Doc or ECO #:	ECO-71152-002	Date:	12/09/2019	Author:	JRK
	Rev. #:	A				
Engineering Change Order (ECO)	Engineering Approval:	aeg	Date:	12/09/2019	Quality Approval	DO

P/N #:	71152	Effective Date:	December 9, 2019
Title:	PRO4 ULTRA ICB Panel Dell EOL Update

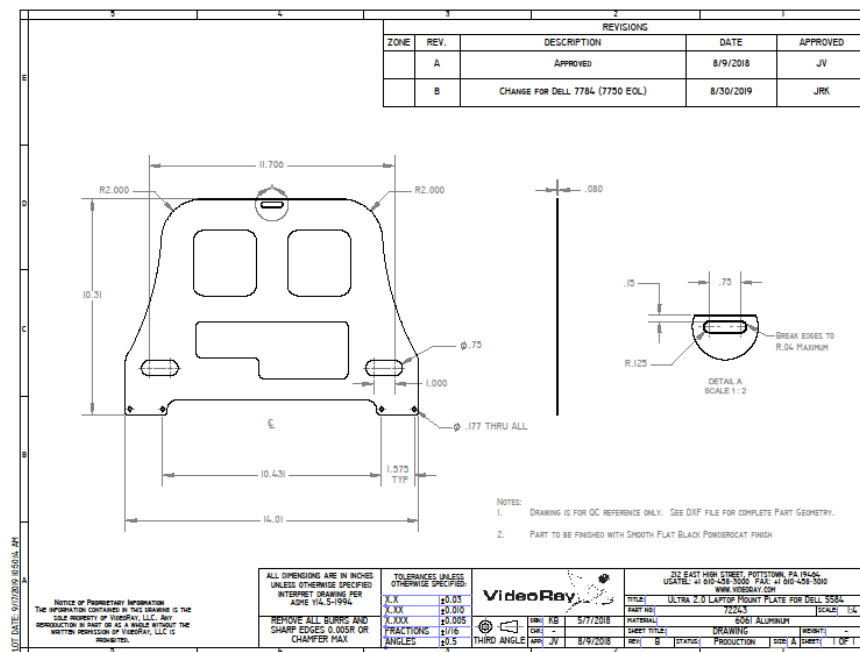
The current Dell 5570 computer in the ULTRA ICB Panel went EOL. It was replaced with the Dell 5000 series 5584, and a new Mounting plate was also created to fit the new computer.

The Dell 5570 Went EOL, and was replaced by the 5584. The feet on the new model, and the sir ducting were in different locations which caused the need for a new mounting plate.

Remaining 5570 Units and original mounting plates should still be used until stock is depleted, then use the replacement units.
